PLANNING COMMISSION PUBLIC HEARING & WORKSHOP

File No: SP 22-04 & CUP 22-01 Agricultural Chemical Fertilizer Storage and Distribution Facility

The Site Development Review application is requesting an agricultural chemical and fertilizer storage and distribution facility. The site includes a 7,380 square foot 2-story (14,760 square foot total) administration office building, a 52,500 square foot operations warehouse with a 2,106 square foot attached office, a 71,858 square foot dry fertilizer building with an attached rail and truck covered loading area, a 11,250 square foot maintenance shop/ laboratory with an attached 4,500 square foot covered wash pad, a 28,080 square foot liquid fertilizer tank farm on a concrete pad with a fabric structure cover, 49 passenger vehicle parking spaces, a new access road, and a new railroad spur. The Conditional Use Permit is requested for the fertilizer production.

AO-4

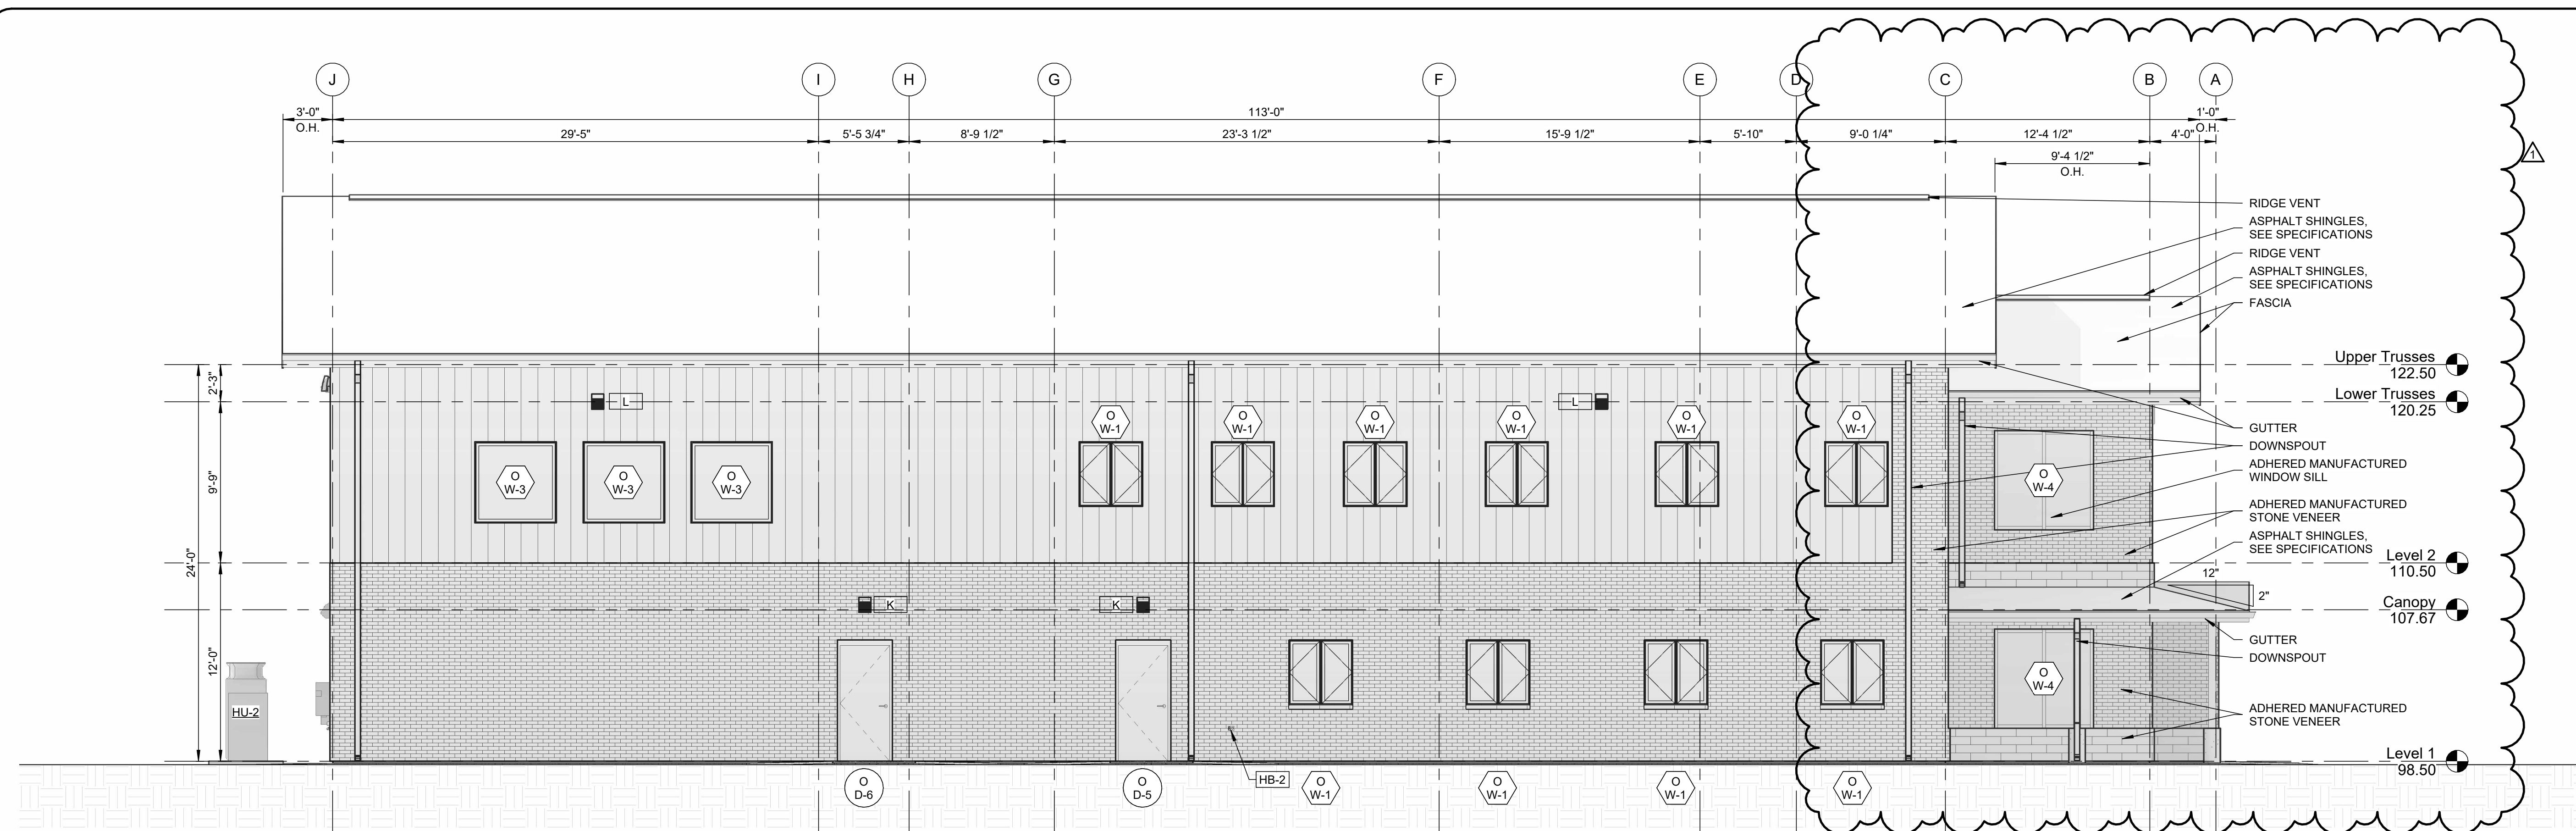
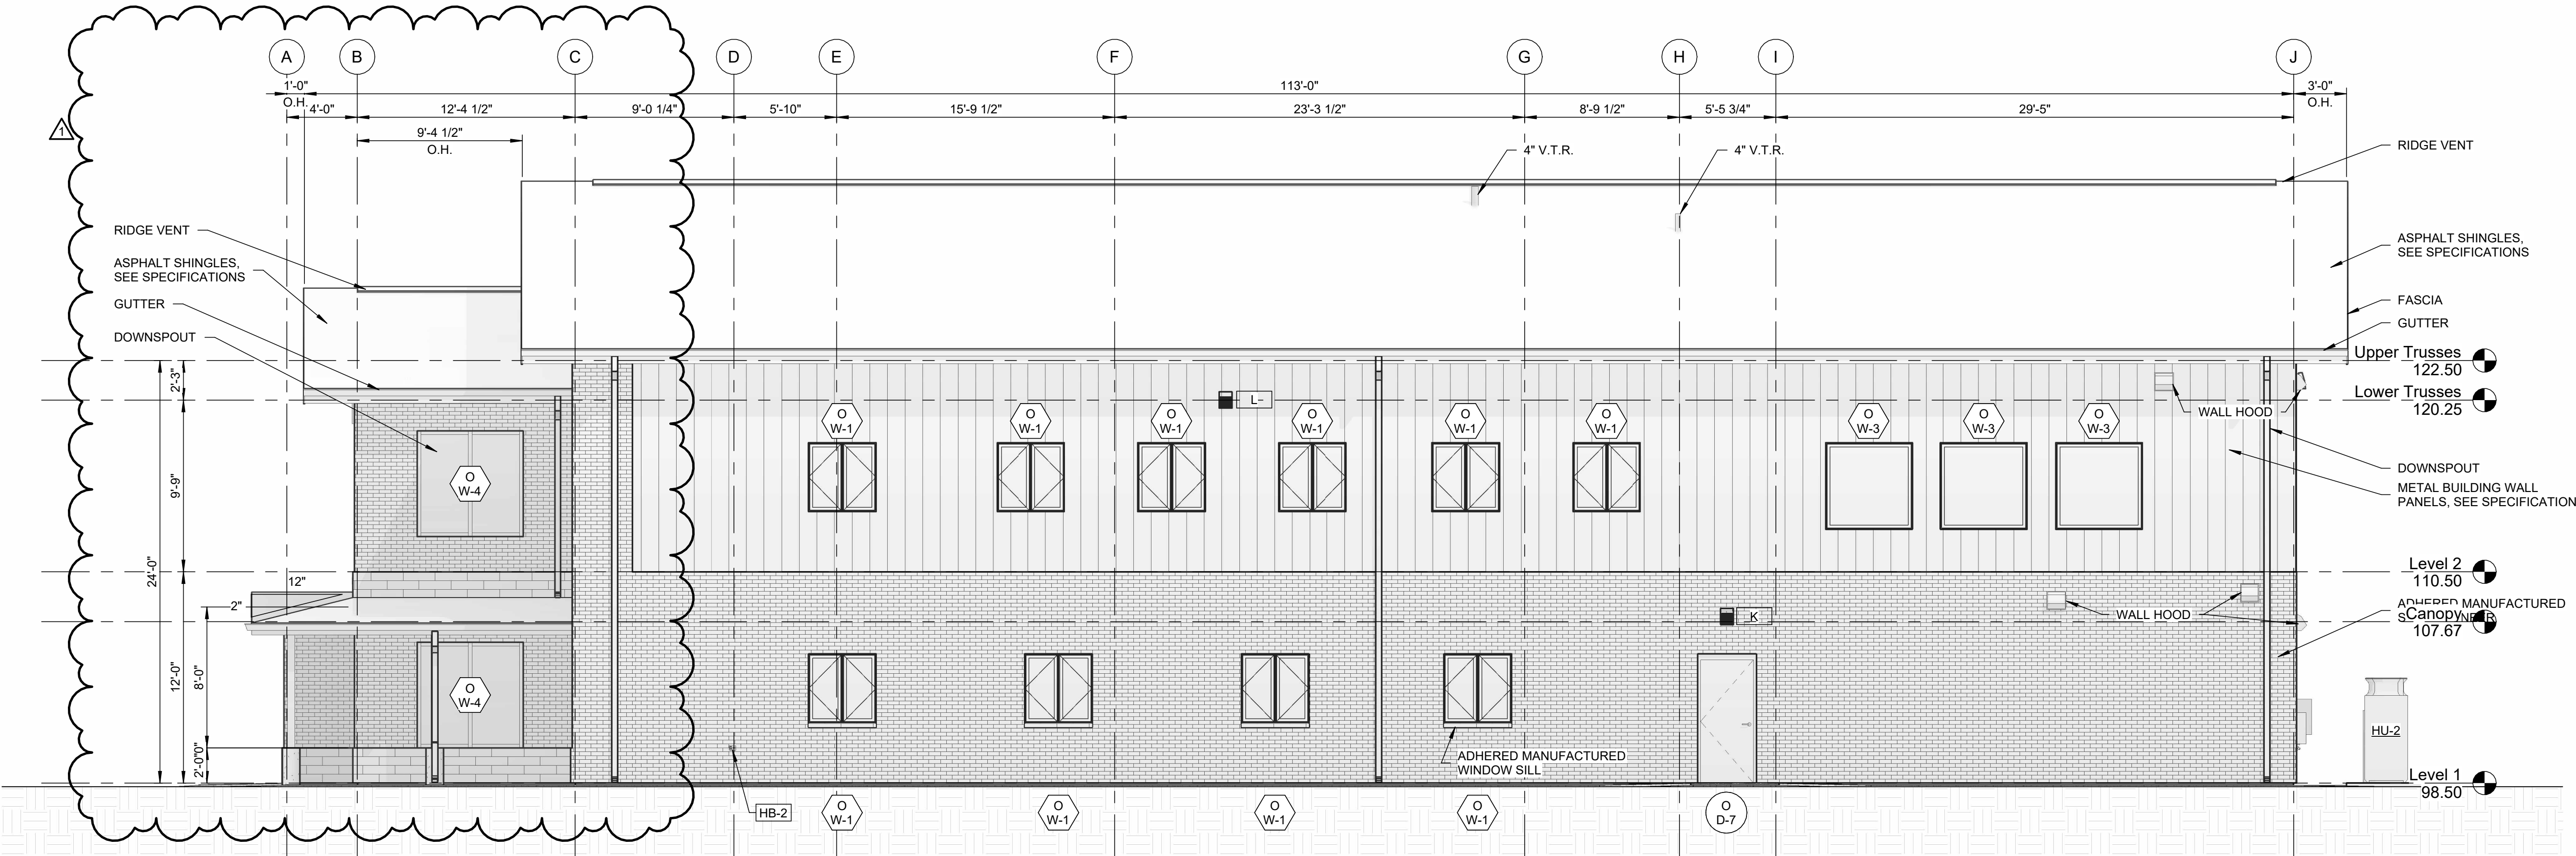
ANALYSIS: This requirement only applies to the office building. This section was revised in July of this year, so the new standards apply. As submitted the elevation of the office building appears to be a combination of metal wall panels and stone veneer. The stone veneer appears to cover most of the front façade and the first 12 feet of the exterior walls on three sides. The proposed design addresses the requirement for a variety of materials. The front façade of the structure features gables and different roof elements at each level of the building. These meet the requirements for the required architectural features on the facade. Other sides of the structure are addressed later. It should be noted that the elevations show an electronic message board on the façade. This is not permitted without a separate Sign Permit and Conditional Use Permit.

- The applicant's narrative states that there are window projections, though the elevations do not seem to show any projecting windows (like bay windows for example). It seems that this would not qualify as an architectural feature.

Using staff's interpretation of this standard the building does not meet the requirement on three of the sides. A condition of approval has been added to require two additional architectural features on three sides of the structure. The proposed condition of approval also gives the

ANALYSIS: The project does not comply with this requirement. A condition of approval has been added to provide the required rain protection.

- Prior to issuance of building permits, the applicant shall provide revised building elevations for the office structure that incorporate at least two additional architectural elements listed in Development Code section 3.26.030(3) on each side of the structure, except the front which already meets the standards. The Community Development Director will determine if the additions meet the standard.

- Prior to issuance of building permits, the applicant shall provide revised building elevations for the office structure that incorporates at least a three feet deep area intended to provide a rain shelter for pedestrians near the entrance of the structure, as required in Development Code section 3.26.030(6). The Community Development Director will determine if the additions meet the standard.

12. Prior to issuance of building permits, the applicant shall provide revised building elevations for the office structure that incorporate at least two additional architectural elements listed in Development Code section 3.26.030(3). The Community Development Director will determine if the additions meet the standard.

13. Prior to issuance of building permits, the applicant shall provide revised building elevations for the office structure that incorporates at least a three-foot-deep awning or other architectural feature intended to provide a rain shelter for pedestrians near the entrance of the structure, as required in Development Code section 3.26.030(6). The Community Development Director will determine if the additions meet the standard.
